A REPAIR

## ON-SITE SEWAGE DISPOSAL SYSTEM HOWARD COUNTY HEALTH DEPARTMENT BUREAU OF ENVIRONMENTAL HEALTH

ADDRESS: 3312 Hipsley Mill Road PROPERTY OWNER: George Chandler

4-28-03 800140139 - BDRM ADDITION

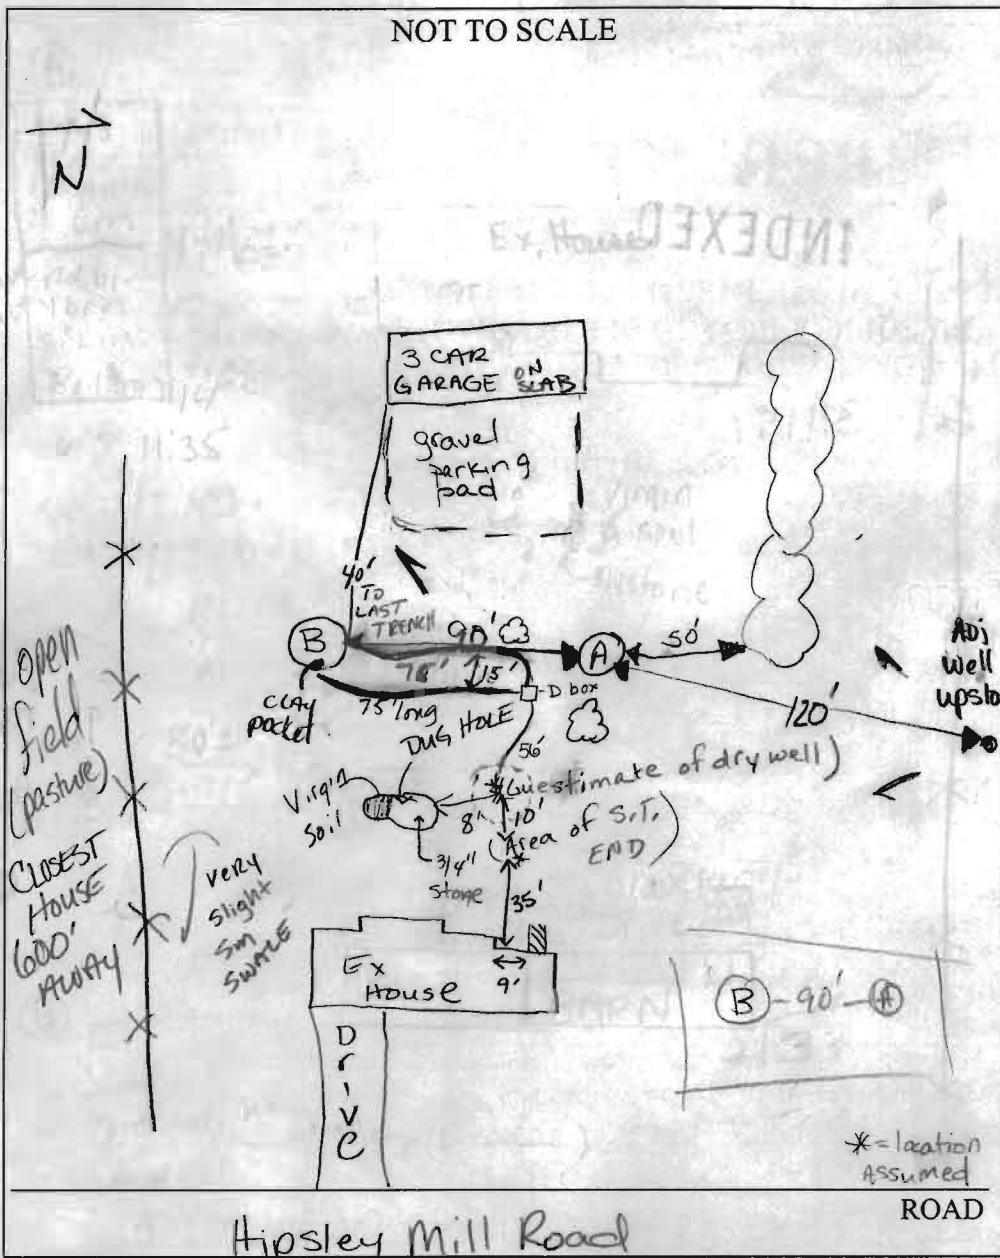
TRENCHES:	Trench to be <u>3</u> feet wide. Inlet <u>6</u> feet below original grade. Bottom maximum depth <u>8</u> feet below original grade. Effective area begins at <u>6</u> feet below original grade. <u>2</u> feet of stone below distribution pipe.
LOCATION:	<u>KEEP Ex D-Well as storage. Run pipe to d. box &amp; 2-75' trenches; 12 CTC.</u>
PURPOSE:	Septic system has failed and one bedroom addition is being built. Call for inspection when ground is opened so sanitarian can recommend repair.

PRE-CONSTRUCTION 4-23-03 DRYWELL FULL; Perc hole at edge of drywell  
 of gravel began pouring in at 4'. Filled hole. Digging  
 INSTALLATION in backyard for trench system specs.  
 Surrounding wells NOT AN ISSUE, Adj LOT'S well  
 upslope & >100' away. SEE SOIL PROFILES FOR TEST  
 HOLES A & B. Homogeneous soils OF CLM to ~5', transition to G,  
 then silm w/ small saprolite frags ~25% below 6'. Perc  
 time avg. 16 min, INSTALL AS DISCUSSED SEE SPECS ON FRONT- (KN)  
 4-25-03 Pumped S.T., replaced pipe between s.t. + Dry well. Shot to 15' etc  
 Plenty of repair area. OK TO COVER 1st trench. 2nd trench should be like  
 FINAL INSPECTOR Race Noonan DATE OF APPROVAL 4/28/03  
 shown: verify. (KN) 4/28/03 OK TO cover 2nd trench (KN)
